SENIOR CANYON MUTUAL WATER COMPANY
Ojai, California

FEMA Funding Facilities Repair Service Area Pipeline F2 – Nightingale Pipeline Project

ADDENDUM NO. 1

April 25, 2025

C-03

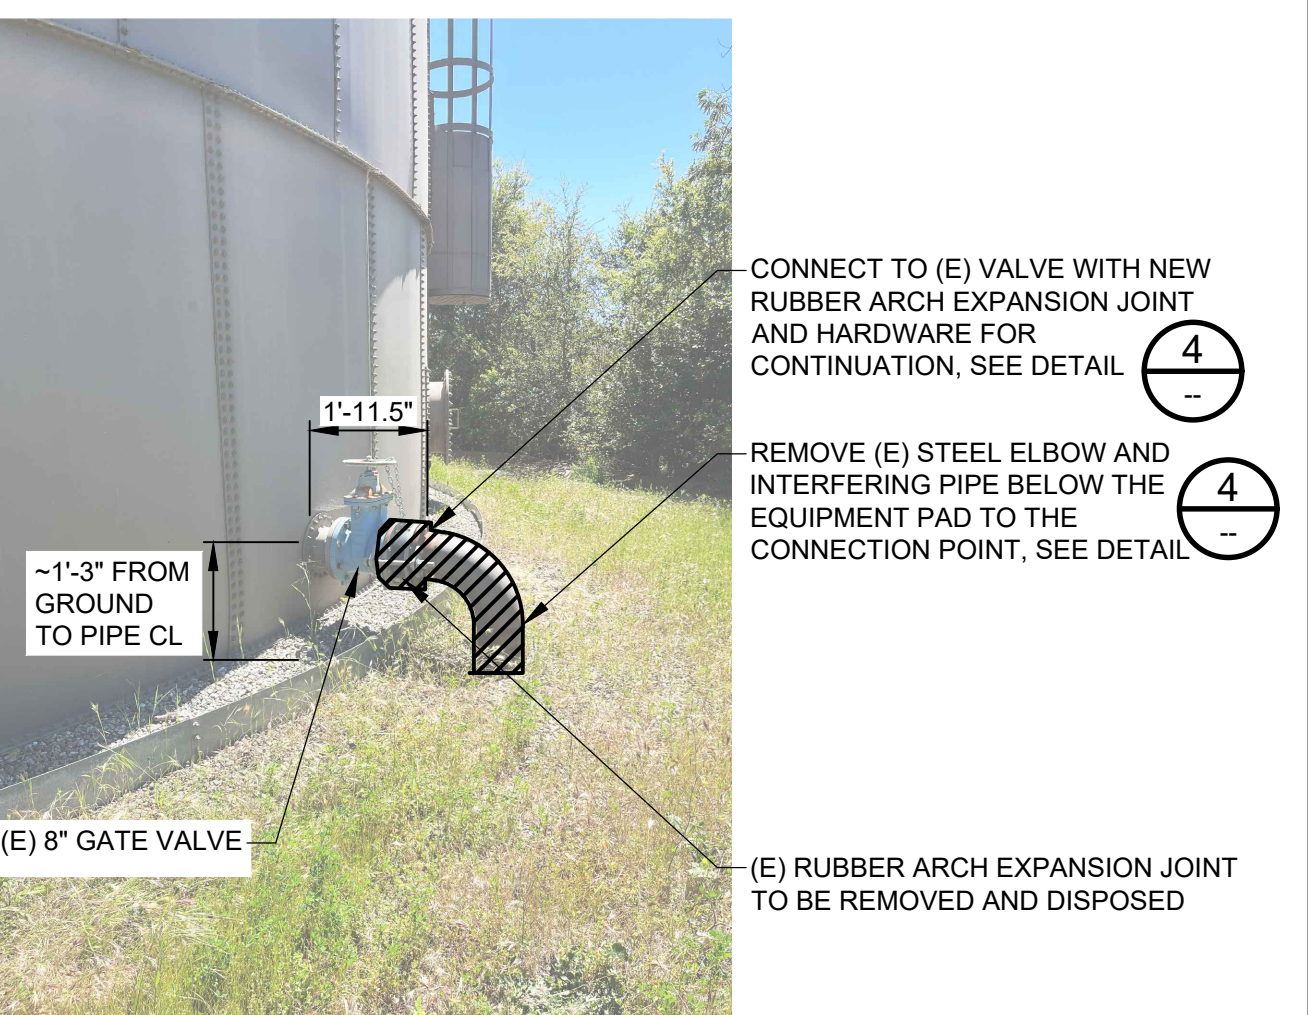
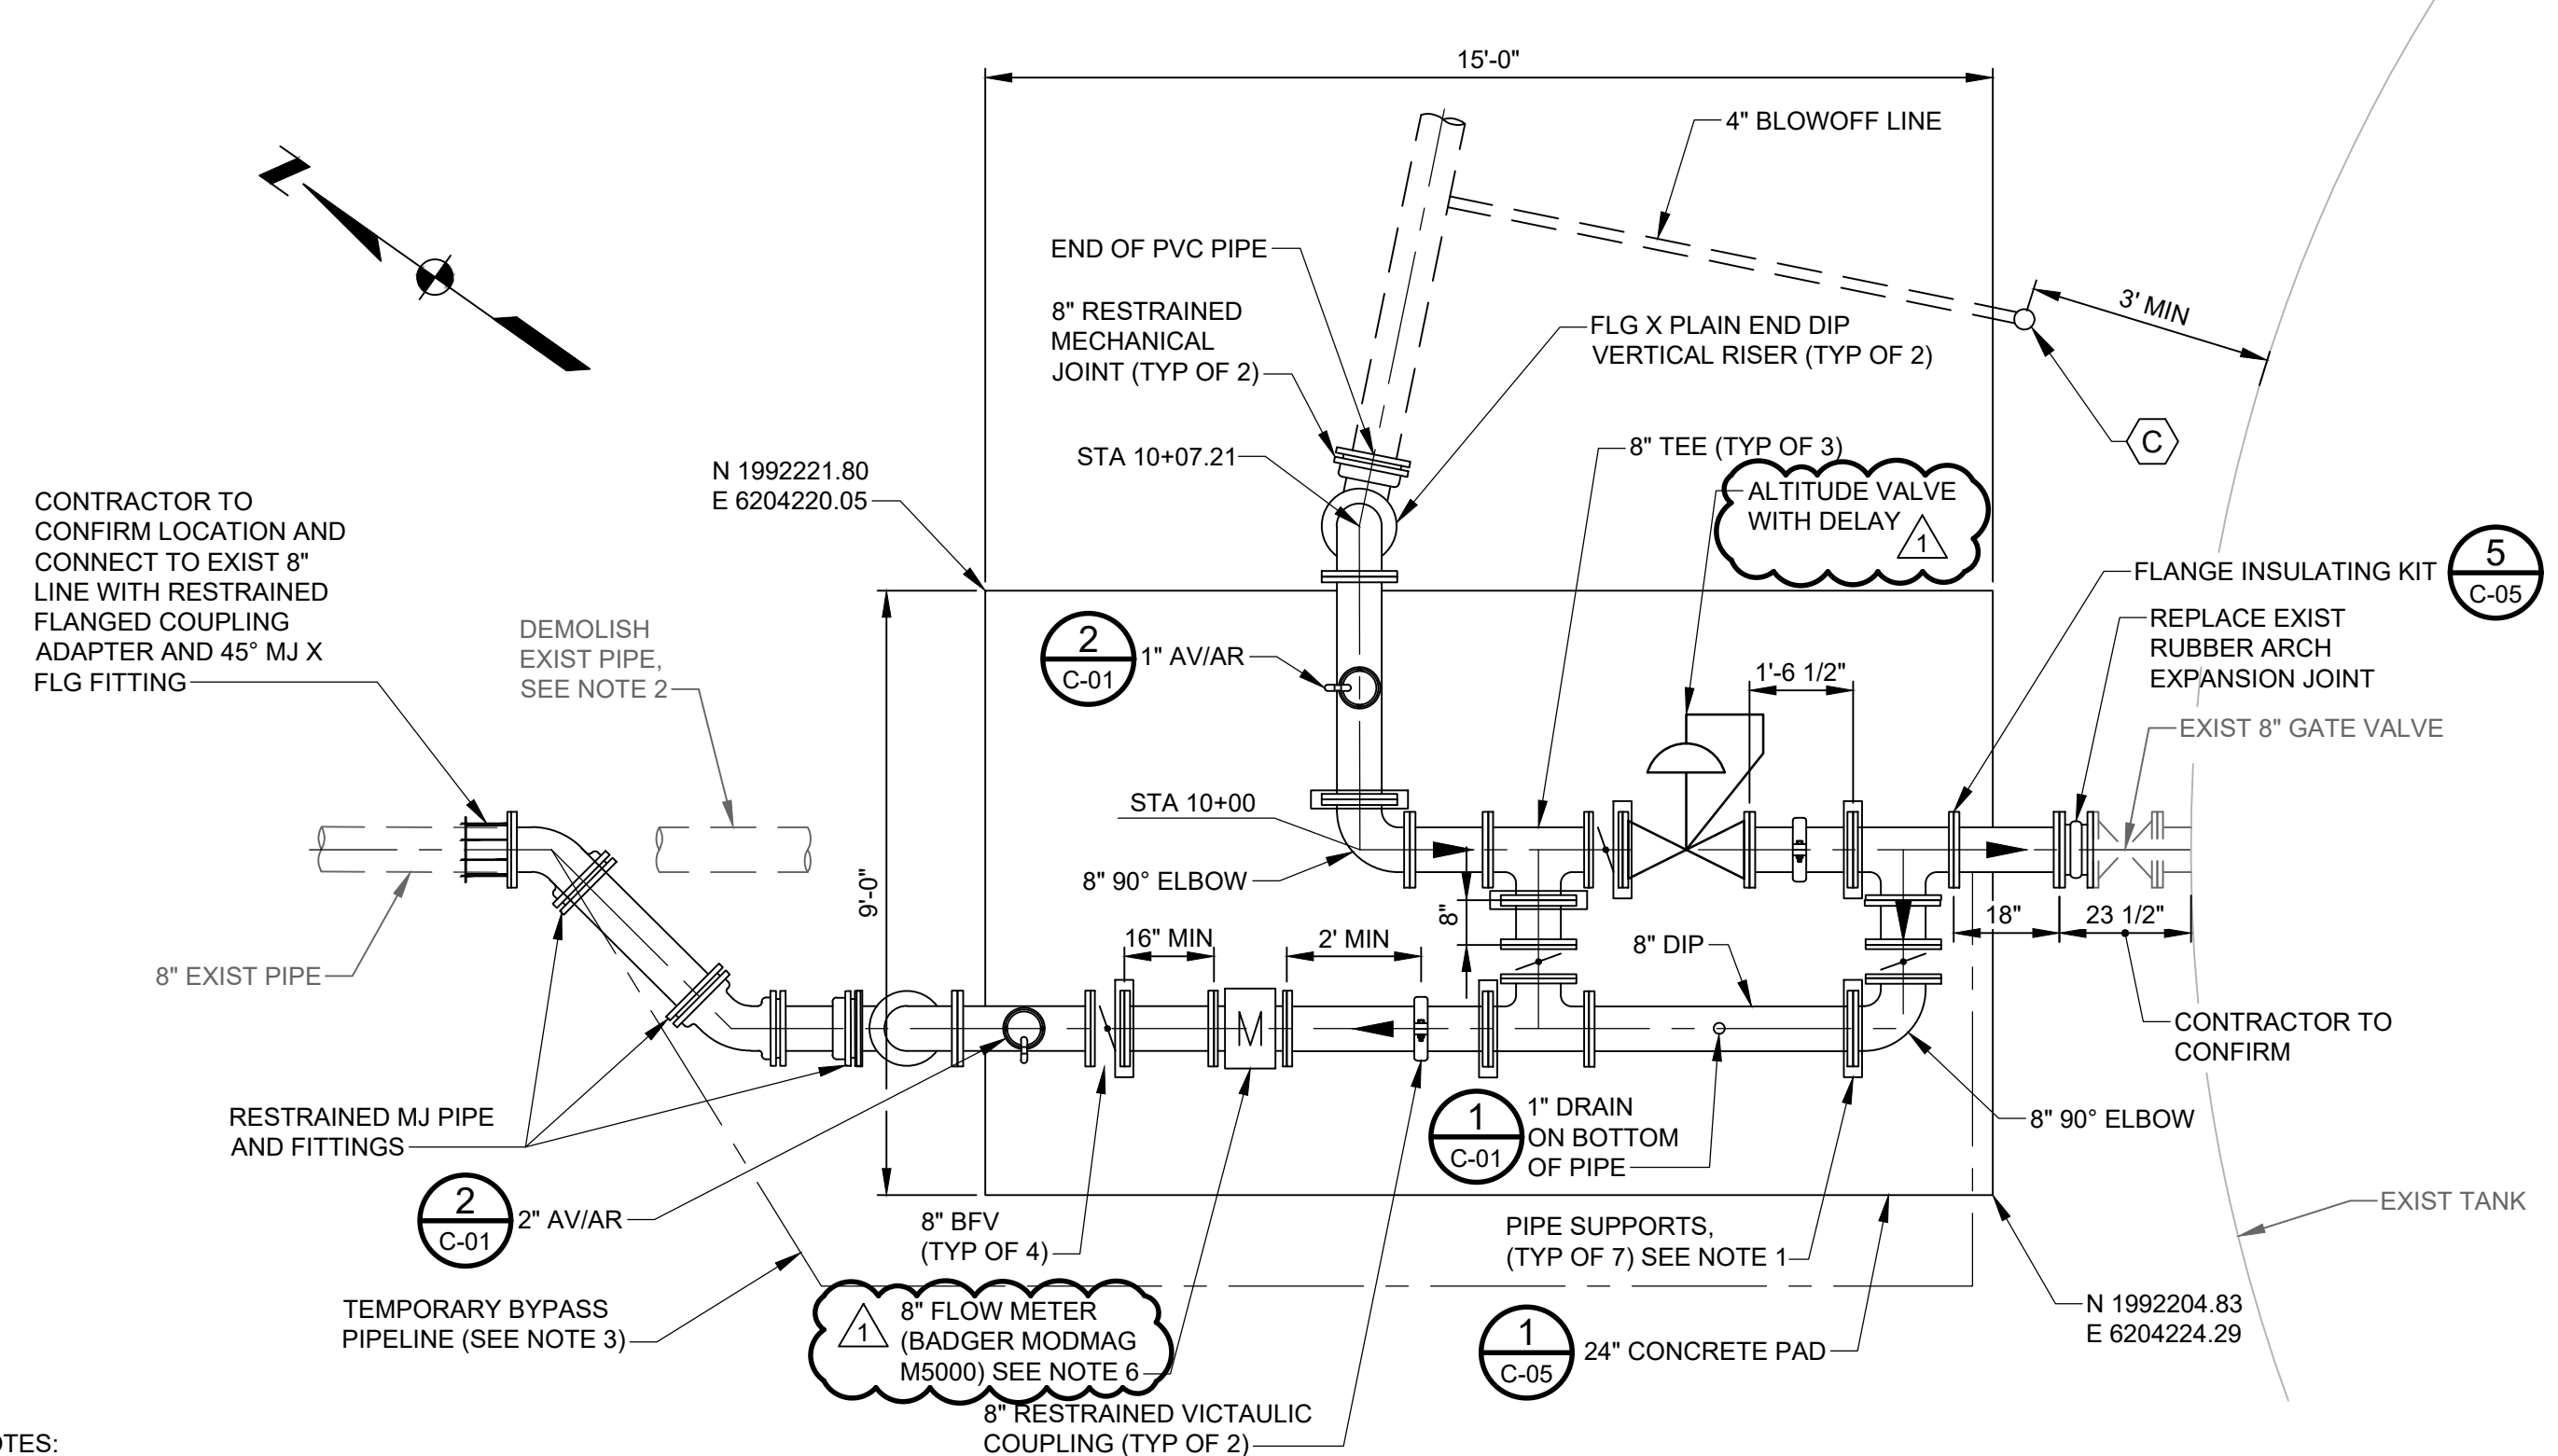
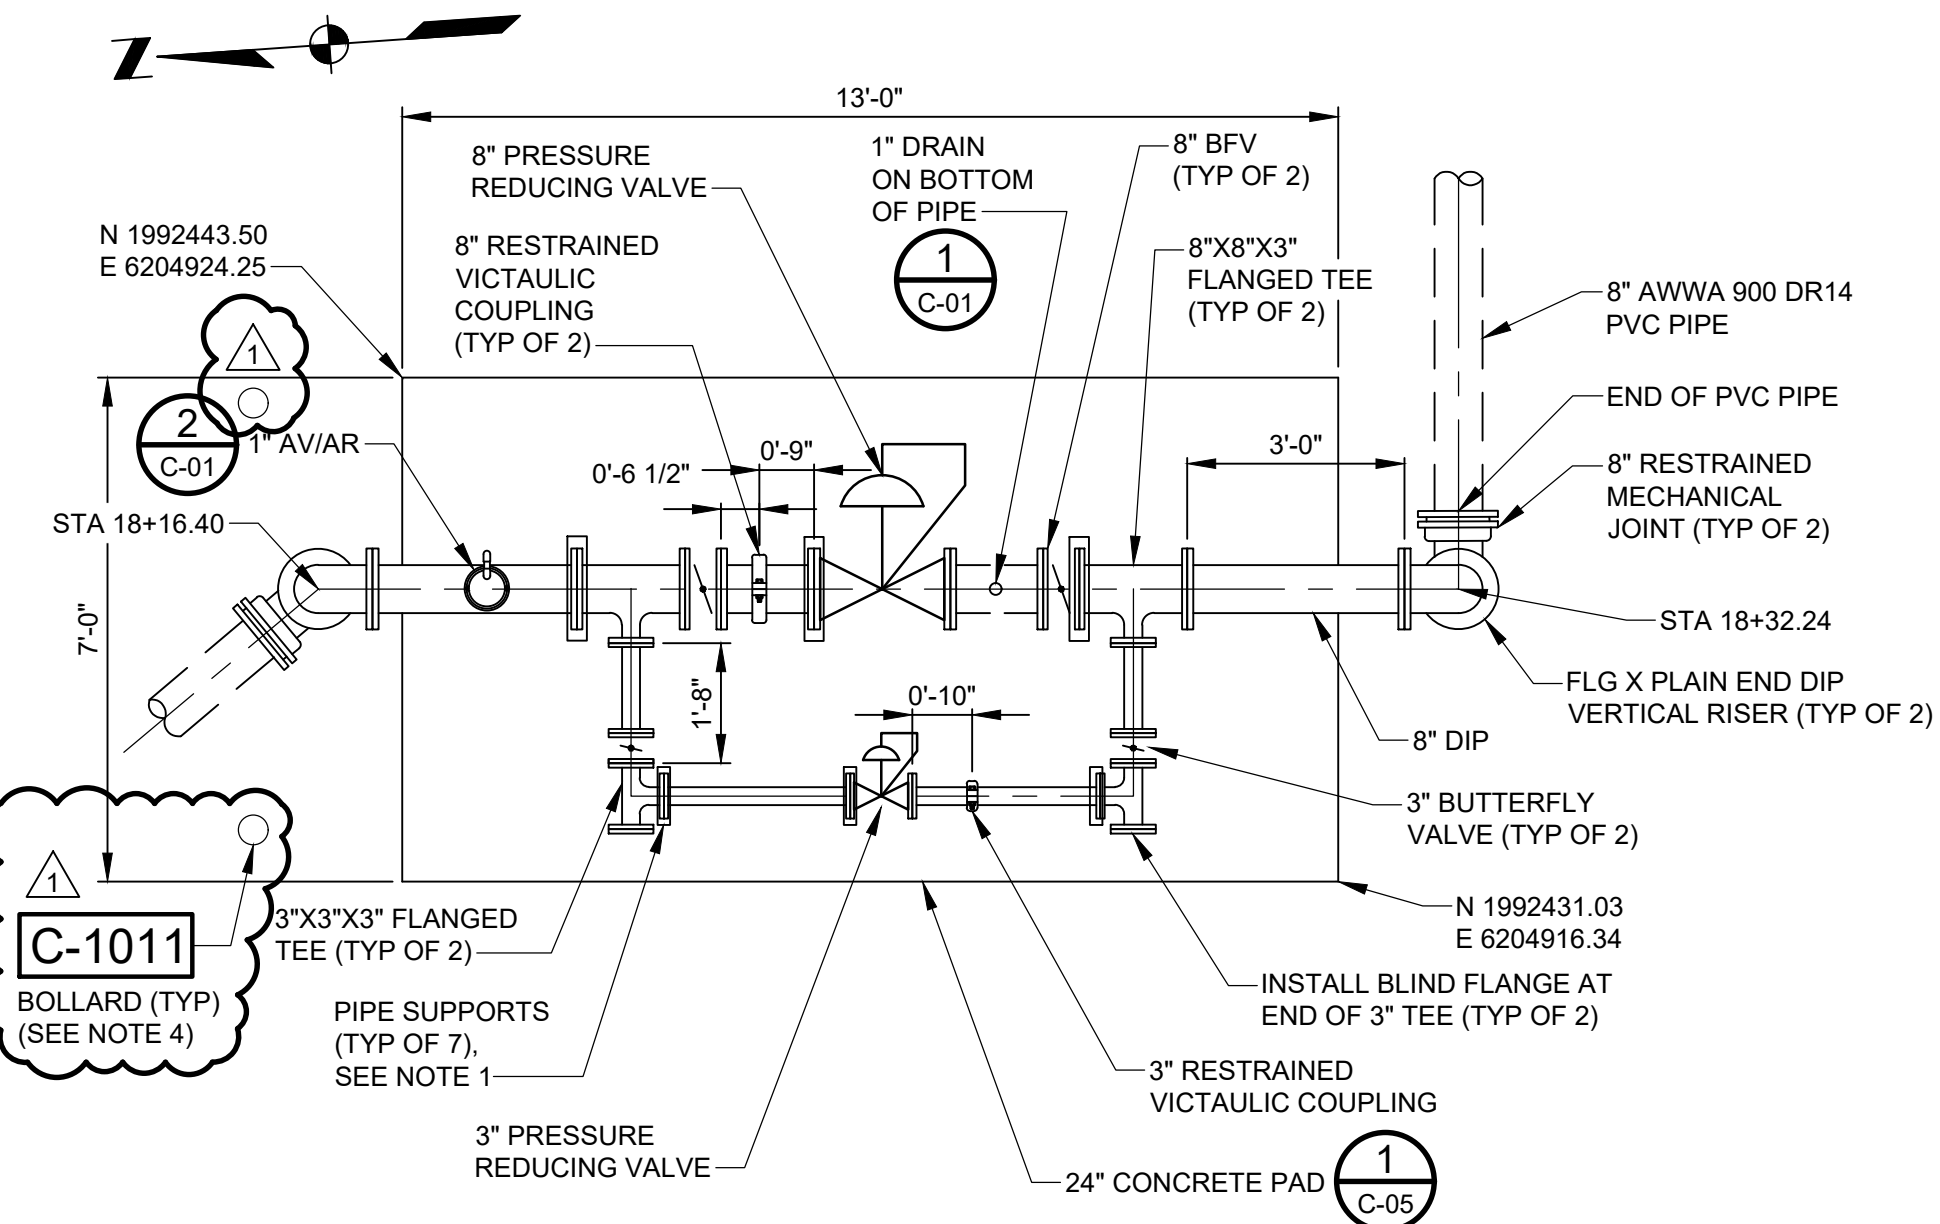
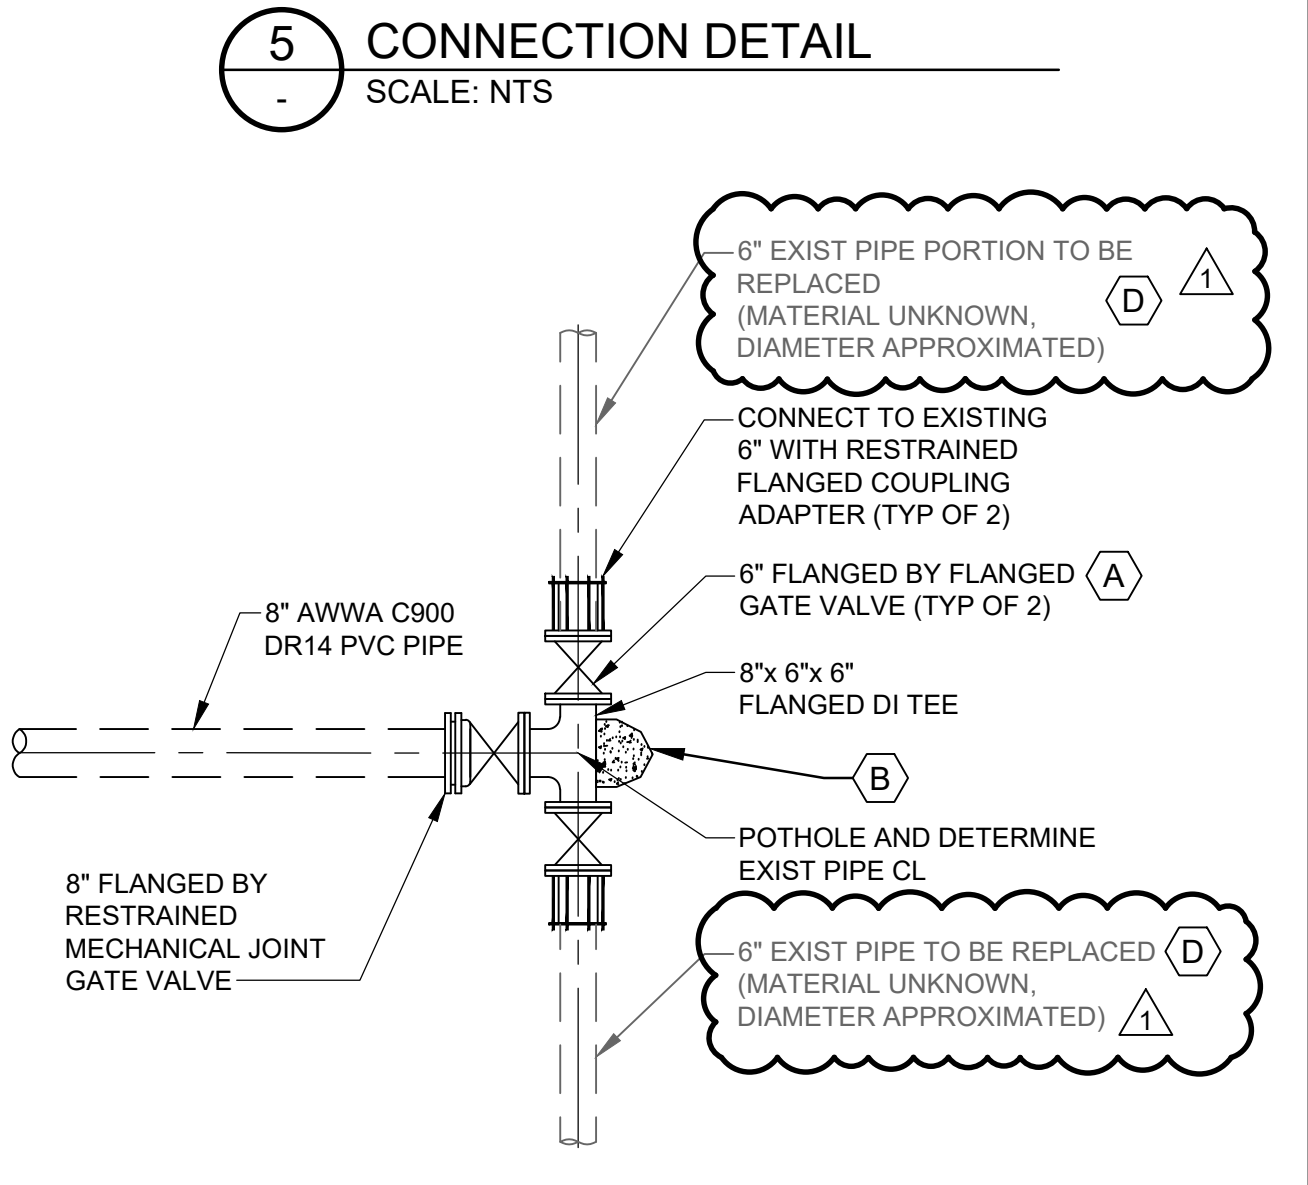
Item AD1-12 Replace Drawing C-03 in its entirety with the revised Drawing C-03 dated 04-2025, attached.

D. THE EXISTING PIPELINE IN MCANDREW SHALL BE REPLACED FROM THE NEW TEE TO WHERE THE PIPE DAYLIGHTS BEFORE CROSSING THE BRIDGE (APPROXIMATELY 17 LF OF NEW DR14 PVC) AND APPROXIMATELY 60 LINEAL FEET NORTH FROM THE NEW TEE (APPROXIMATELY 60 LF OF NEW DR14 PVC). THE NEW REPLACEMENT PIPE SHALL MATCH THE EXISTING PIPELINE DIAMETER. IT SHOULD BE ASSUMED THAT THE EXISTING PIPELINES TO BE REPLACED ARE 6" IN DIAMETER. AT THE END OF THE 60 LF STRETCH OF REPLACEMENT, INSTALL A NEW BURIED 6" GATE VALVE BEFORE TYING INTO THE EXISTING PIPELINE. GATE VALVE SHALL BE FLANGED BY RESTRAINED MECHANICAL JOINT. CONNECTIONS TO EXISTING PIPELINES SHALL BE MADE WITH RESTRAINED FLANGED COUPLING ADAPTERS. IF THE EXISTING PIPELINE IS LESS THAN 6" IN DIAMETER, A CREDIT CHANGE ORDER SHALL BE PROVIDED FOR THE PIPELINES AND APPURTENANCES.

- REMOVE EXISTING PIPE UPSTREAM FROM NEW TIE IN POINT AND UP TO THE EXISTING VERTICAL 90 DEGREE BEND THAT CONNECTS TO THE EXISTING RUBBER ARCH EXPANSION JOINT. NO EXISTING PIPE SHOULD REMAIN UNDERNEATH THE NEW SLAB. THE EXISTING TRENCH SHOULD BE BACKFILLED WITH 2 SACK SLURRY.

- CONTRACTOR TO ROUTE AN 8" DIAMETER TEMPORARY BYPASS PIPELINE DURING CONSTRUCTION RELATED TO THE TANK CONNECTION. TEMPORARY PIPELINE TO BE DISINFECTED PER THE SPECIFICATIONS. CONNECTIONS ON EITHER END TO BE MADE BETWEEN 9AM AND 3PM.

- EQUIPMENT PAD FG 1251.15 TANK OUTLET CENTERLINE ANTICIPATED TO BE 1252.40. CONTRACTOR TO VERIFY ELEVATION AND COORDINATE WITH SENIOR CANYON AND THE ENGINEER PRIOR TO FINALIZING THE PAD FG.

- INSTALL TWO (2) 1" DIRECT BURY CONDUITS WITH CONDUCTORS FROM THE NEW FLOWMETER TO THE EXISTING SCADA BOX THAT IS LOCATED APPROXIMATELY 35' NORTHWEST OF THE EXISTING OUTLET PIPING OFF THE TANK. TERMINATE CONDUITS ABOVE GRADE AT THE SCADA BOX USING RAIN-TIGHT HUBS MANUFACTURED BY MYERS, O.Z. GEDNY, APPLETON OR APPROVED EQUAL. DURING CONSTRUCTION, PLUG CONDUIT ENDS WITH APPROVED MOISTURE-RESISTANCE SEALANT, DUXSEAL OR 3M SEAL SPRAY, TO PROTECT AGAINST DUST AND MOISTURE. CONNECTIONS TO SCADA TO BE MADE BY OTHERS.
